## Executive Director's Recommendation

| <b>PROJECT</b><br><b>Hirshhorn Museum and Sculpture Garden</b><br><b>Revised Museum Entrance Sign</b><br>700 Independence Avenue, SW<br>Washington, DC | <b>NCPC FILE NUMBER</b><br>7940   |

The Smithsonian Institution is requesting preliminary and final approval of a redesigned sign for its southeastern Hirshhorn Museum entrance. NCPC previously approved a design for the entrance sign at its meeting in January 2018; however, the sign was never installed. Since then, the Smithsonian has developed a new design to be more compatible with the iconic appearance of its Hirshhorn Museum building. The revised design changes the material of the sign to bronze and reduces the height, width, and depth of the individual letters from the previous design.

# Hirshhorn Museum and Sculpture Garden Revised Revolving Door Sign

# Proposed Revised Entry Signage

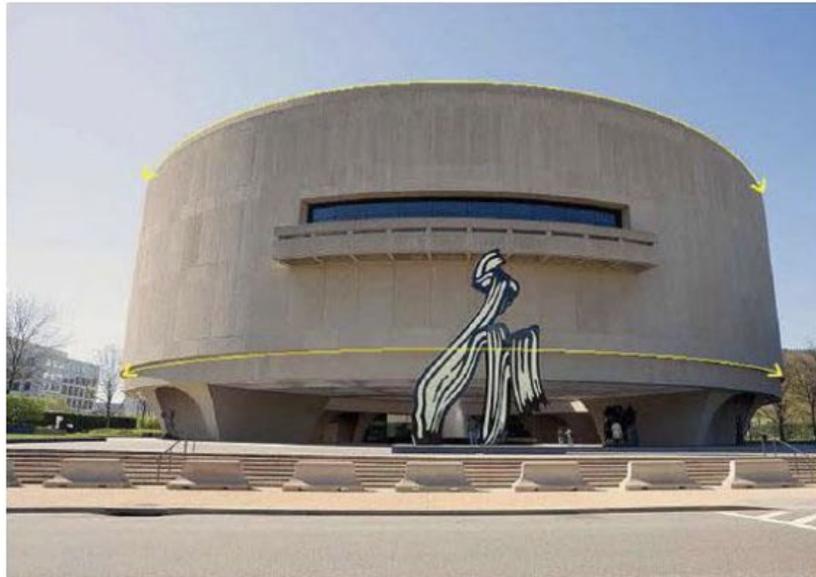
The proposed revision to the project suggests changing the material of the sign to bronze and reducing the height, width, and depth of the individual letters.

Rendering of white acrylic material over southeast entrance

previously-approved sign - 2018

Rendering of non-directional bronze material over southeast entrance

**CURRENT PROPOSAL**

## Details of Letters and Mounting System (Revised)

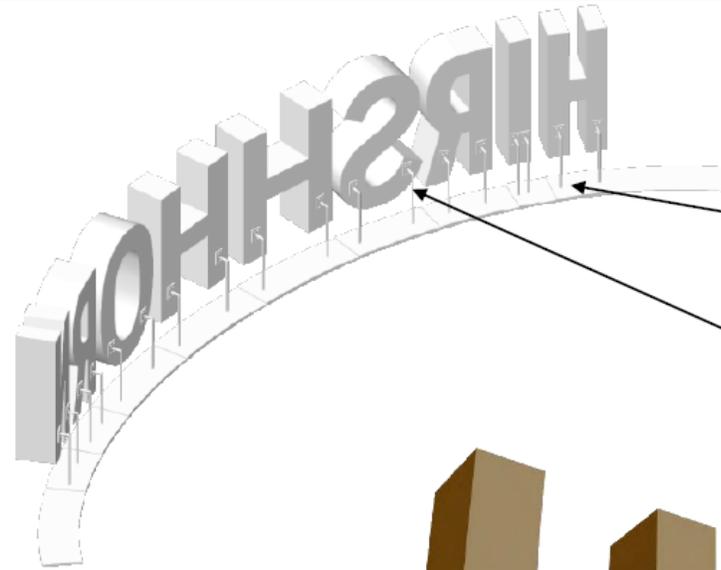
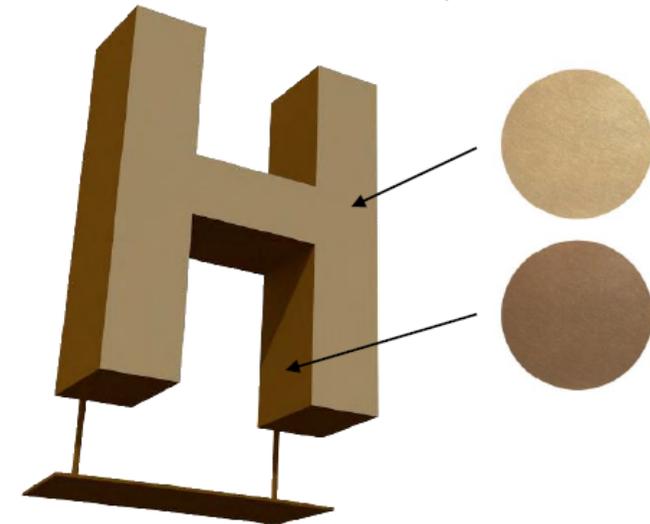
The revised design reduces the letters in size from 18 inches in height and 6 inches in depth to 15 inches in height and 4 inches in depth, creating a slimmer profile. This is an eco-friendly option, as compared to the original acrylic design, by using recyclable and sustainable metals. The letters will be stud mounted and attached to a steel base plate. How the steel base plate attaches to the top of the door is yet to be determined, but will be a reversible addition. The material of the letters has changed to non-directional finished bronze. The non-directional finish matches the bronze and brass furniture and accents found within the lobby. The face of the letters shall be a lighter bronze patina with the back and return a moderately darker bronze patina to increase legibility. Also to increase legibility, the exact letter placement will be adjusted on site during installation to obtain optimal spacing of the individual letters. The overall width is therefore variable.

steel base rail fastened to top of entranceway, thickness TBD

1/8" thick steel letter base plate mechanically fastened to base rail through slotted holes for adjustability (proposed, TBD)

1/4" steel mounting rod welded to base plate and mechanically fastened to letter backs (proposed, TBD)

15" x 4" letter with light bronze face and moderate bronze patina on the return and back on a steel base and mount, powder-coated to match moderate bronze patina.
